PROPOSED EDITS TO DRAFT #6 (FROM CURT FRANSEN 9/30/26)

Working Draft V.6 09282026 SAP-02 Page 72

Figure 8-8B-5.3 Additional Stories Stepback

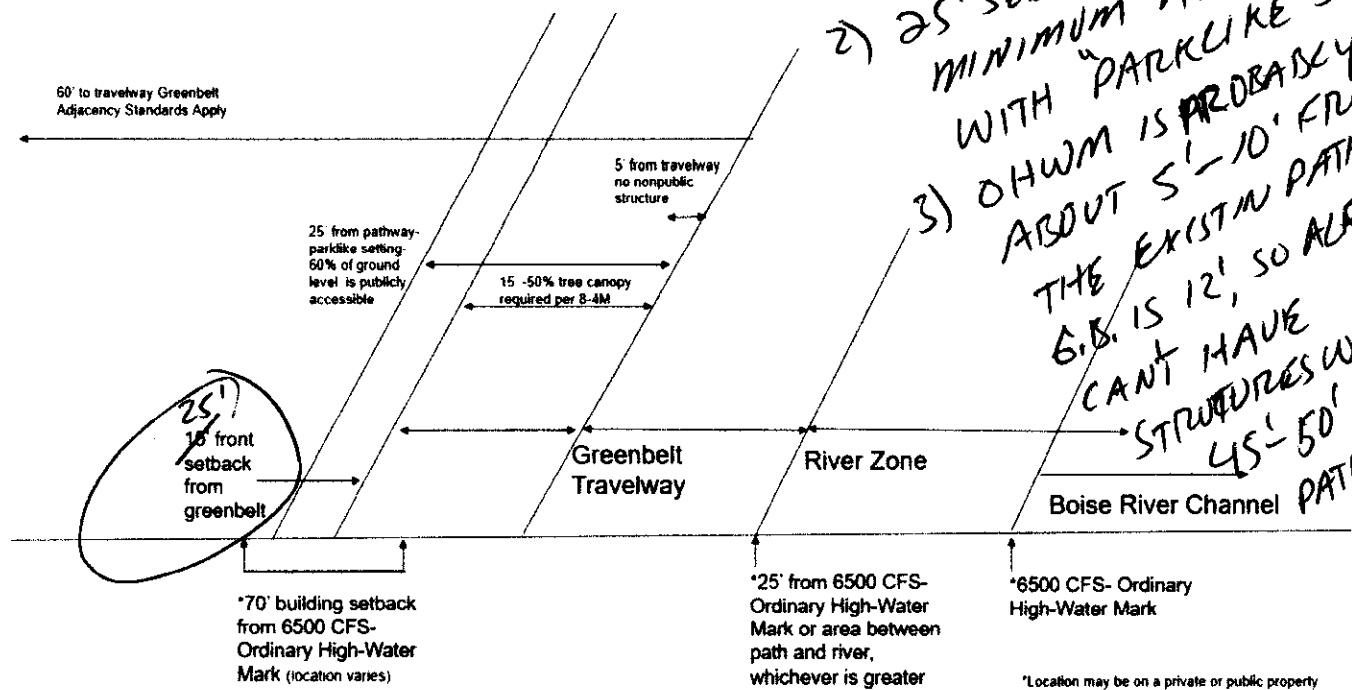
COMMENT:
- DO NOT ALLOW TALL BUILDINGS NEAR THE GREENBELT. MORE THAN 4 STORIES WITHIN 60' OF THE GREENBELT WILL CREATE A SHADED CANYON
- WHERE IS SETBACK?

- 1) WHERE IS SETBACK IN THIS ARTICLE?
- 2) 25' SEEMS LIKE A MINIMUM AND CONSISTENT WITH "PARKLIKE SETTINGS"
- 3) OHWM IS PROBABLY ABOUT 5'-10' FROM THE EXISTING PATHWAY. G.B. IS 12', SO ALREADY CAN'T HAVE STRUCTURES WITHIN 45'-50' OF PATHWAY.
